# CERTIFICATE OF APPROPRIATENESS PLACARD

917 W SOUTH STREET

031-14-MW

- Remove utility chimney;
- relocate rear window

EAST ELEVATION  
 PROPOSED

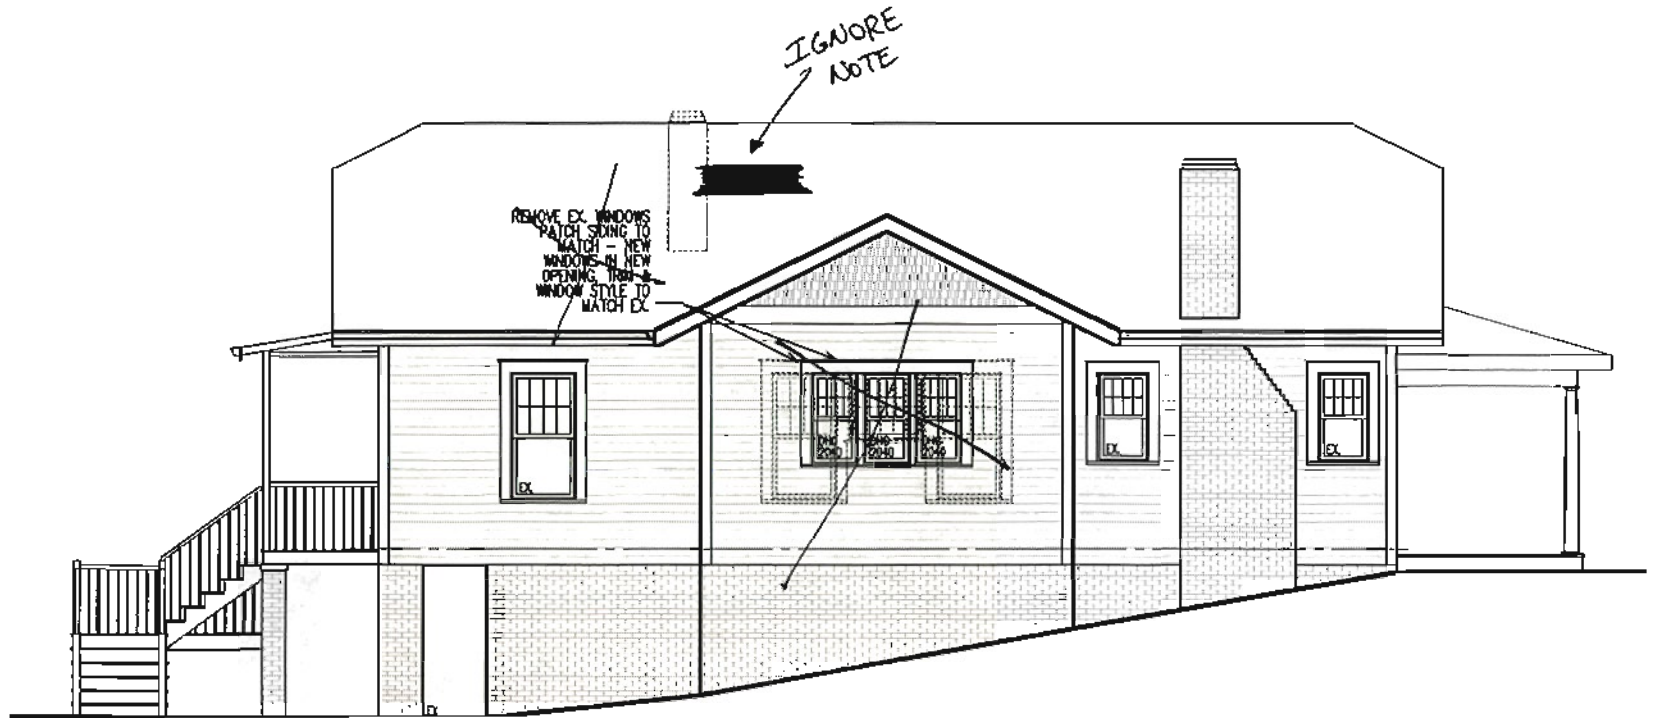
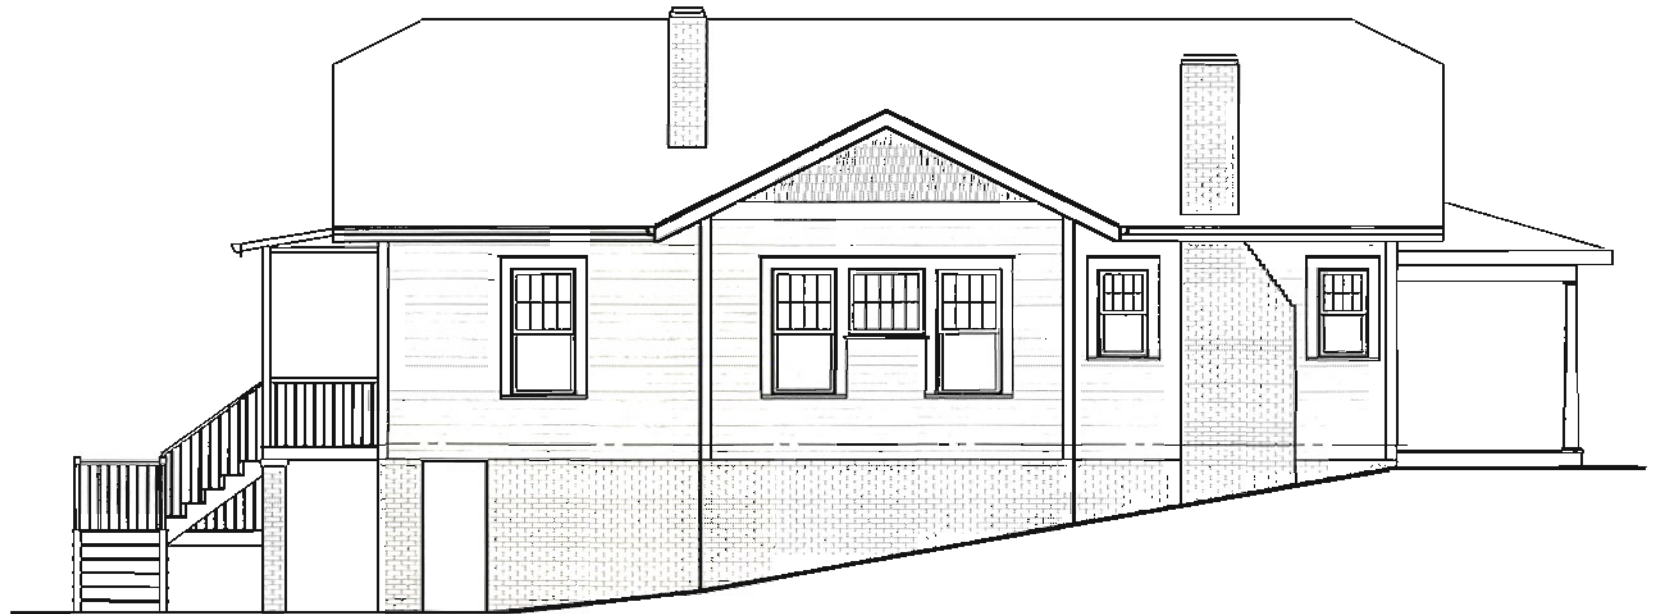
- Please email the photographs included in the application.
- Pending receipt of the emailed photos there is sufficient information regarding the removal of the service/utility chimney.
- Please send close-up photos of the windows on the rear of the house and documentation that the window being relocated and replaced is deteriorated beyond repair. (Guidelines 3.7.5, 3.7.6). Relocation of the existing window clearly meets the Guidelines and is approvable by staff, but there is no evidence to support replacement at this time.
- The three windows proposed for replacement on the east side of the house “contribute to the overall historic character” of the building and cannot be approved for replacement at the staff level (Guidelines 3.7.1, 3.7.13). This item must be forwarded to the COA Committee for review.

- Leave the application as-is and I will forward the whole thing to the COA Committee for review at the April 7 COA meeting.
- File a new COA application for the chimney removal and I will only forward the window items.
- Change the COA to reflect only relocating the rear window and removal the replacement request for the east windows. This would allow the entire application to be approved as a Minor Work.

Please amend the current COA for only chimney removal and rear window relocation.

SOUTH ELEVATION  
PROPOSED

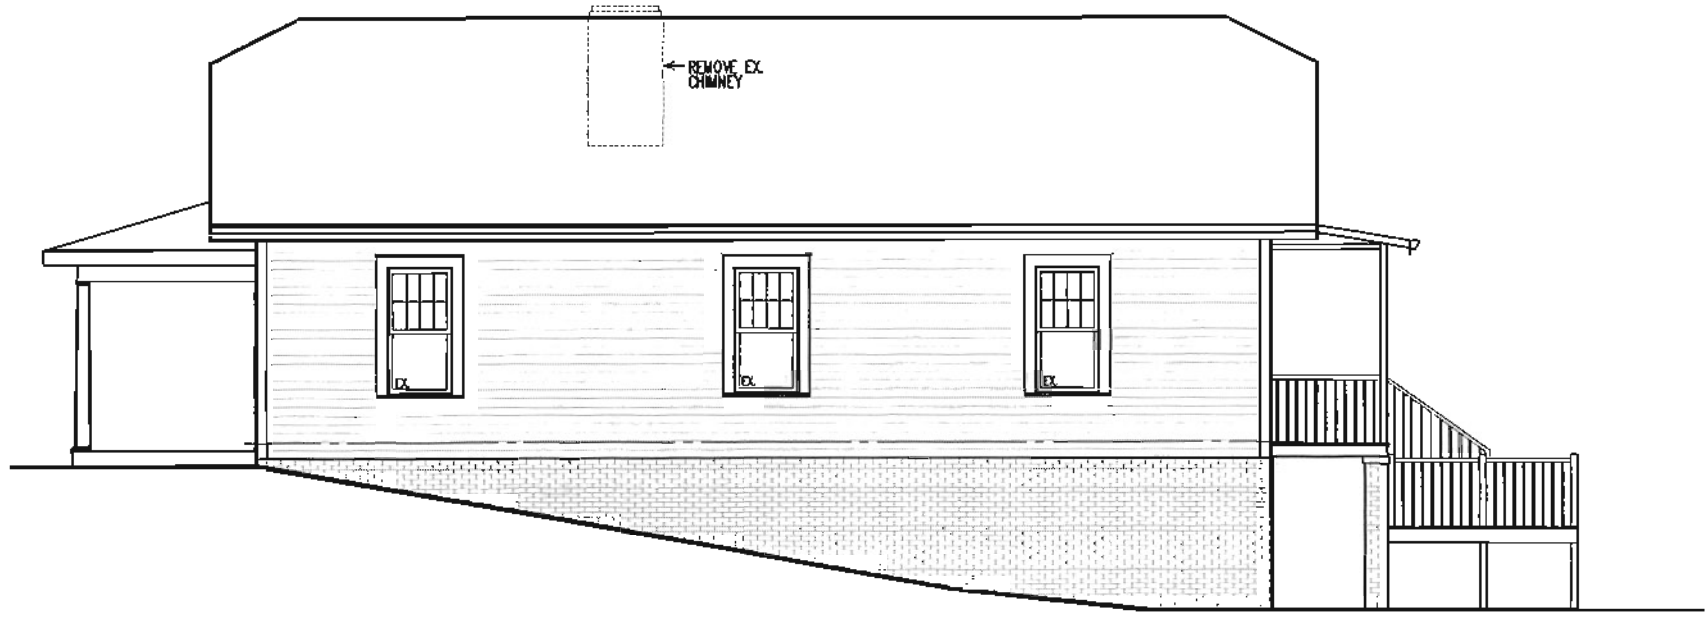
- Please email the photographs included in the application.
- Pending receipt of the emailed photos there is sufficient information regarding the removal of the service/utility chimney.
- Please send close-up photos of the windows on the rear of the house and documentation that the window being relocated and replaced is deteriorated beyond repair. (Guidelines 3.7.5, 3.7.6). Relocation of the existing window clearly meets the Guidelines and is approvable by staff, but there is no evidence to support replacement at this time.
- The three windows proposed for replacement on the east side of the house “contribute to the overall historic character” of the building and cannot be approved for replacement at the staff level (Guidelines 3.7.1, 3.7.13). This item must be forwarded to the COA Committee for review.

relocate existing window & trim
